Type labeling guide for P2582 Freddie

Docnumber	
Status / Version	Proposal v0.51
Editor	Oliver Simon

2. NEEDED CHANGES FOR HF-2W LABEL VARIANT 1 (EURO1, EURO2, US)

1. EXISTING TYPE LABEL

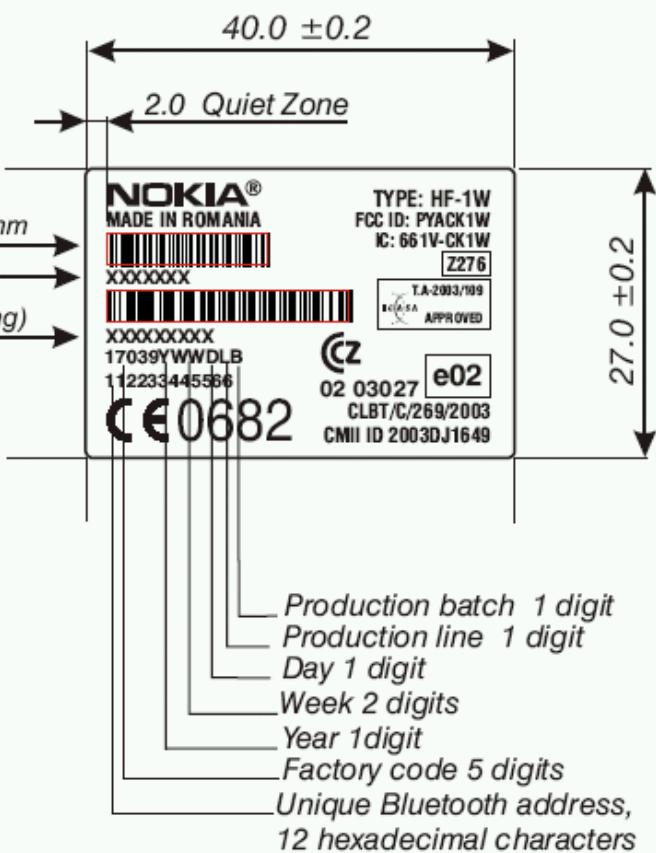
The following steps should describe what changes needs to be done from the existing CK-1W typelabel:

Type designator to be updated from HF-1W to HF-2W

No label needed anymore, so Ccz can be removed

No label needed anymore (CLBT....)

PCT ME 96 label to be added

Remove Z276, as this is part of APAC typelabel

To be removed, as China get's separate variant

FCC to be changed to "FCC ID: OW3HF-2W"

IC-ID to be changed to "IC: 661AA-HF2W"

"FABRIQUÉ EN ROUMANIE" to be added

Label to be updated ([T.A-YEAR/XXX](#))

e-mark number to updated ([02 XXXXX](#))
